Serial: HNP-09-007
10 CFR 50.90

SHEARON HARRIS NUCLEAR POWER PLANT, UNIT NO. 1
DOCKET NO. 50-400/LICENSE NO. NPF-63
SUPPLEMENT TO TECHNICAL SPECIFICATIONS 5.6.1.3.a AND 5.6.1.3.b –
INCORPORATION OF UPDATED CRITICALITY ANALYSES TO REFLECT
REMOVAL OF CREDIT FOR BORAFLEX IN BWR SPENT FUEL POOL
STORAGE RACKS

SHEARON HARRIS NUCLEAR POWER PLANT, UNIT NO. 1
DOCKET NO. 50-400/LICENSE NO. NPF-63
RESPONSE TO ACCEPTANCE REVIEW REGARDING
AMENDMENT TO REMOVE CREDIT FOR BORAFLEX IN BWR
SPENT FUEL POOL STORAGE RACKS

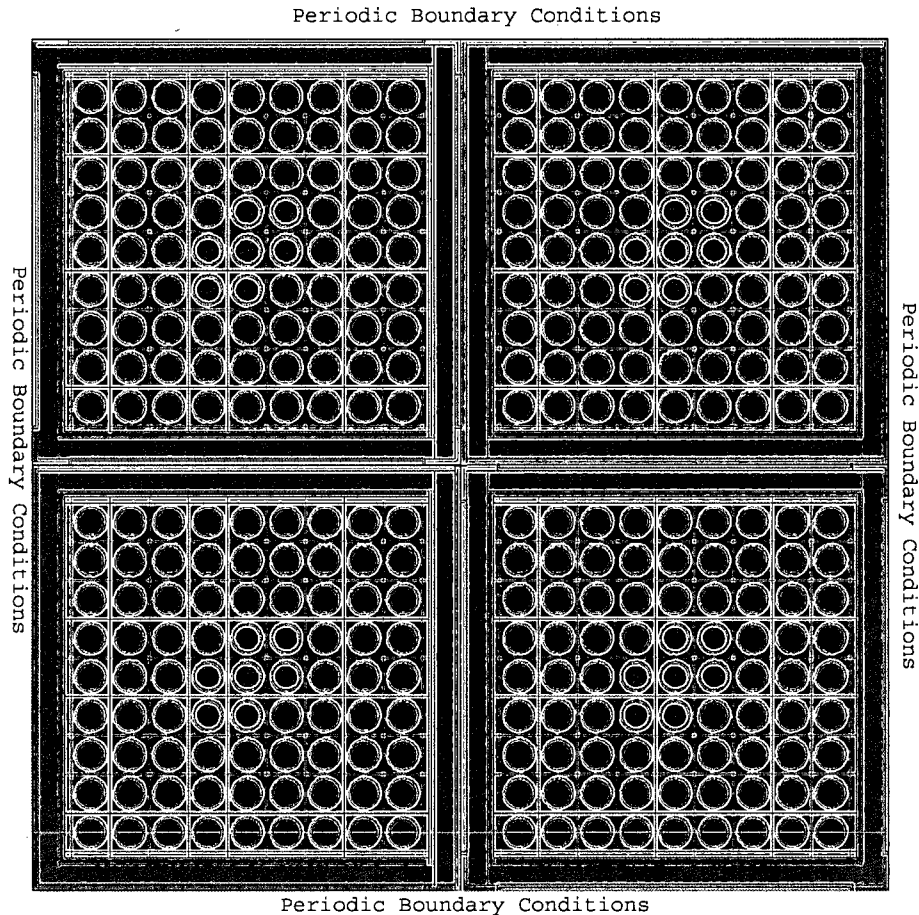
- a) *Figure 3 of HI-2043321 shows the calculational model of a "typical" storage cell. Is this model an approximation of the actual configuration? If so, please show the impact of the approximation on the calculated reactivity.*

Response: The storage cells are composed of stainless steel boxes, joined at the corners in an egg-crate structure. The external box side is equipped with a stainless steel sheathing which holds the Boraflex neutron absorber in place. These boxes are then arranged in a checkerboard pattern, where four storage cells form "developed cells" that can also store spent fuel assemblies. The MCNP model is developed as shown in Figure 3 of HI-2043321. All material thicknesses (stainless steel and water) are preserved and the Boraflex is completely neglected. Additionally, the storage cell pitch is modeled at 6.22 inches, conservatively reduced from the nominal storage cell pitch of 6.25 inches. These conservatisms would more than offset any small reactivity effect associated with the geometry modeling.

An additional MCNP4a calculation was performed with the storage cell box and stainless steel sheathing modeled explicitly.

Geometry	Calculated k_{eff}	Sigma
Figure 3	0.9576	0.0003
Explicit geometry	0.9585	0.0003

The results in the table show that the simplified geometry modeled in the main part of the report provides an accurate representation of the actual geometry. While the explicit geometry provides a slightly larger k_{eff} , the small increase would be offset by modeling the storage cell pitch at 6.25 inches.

A plot of the explicit geometry as created in MCNP4a is shown below:
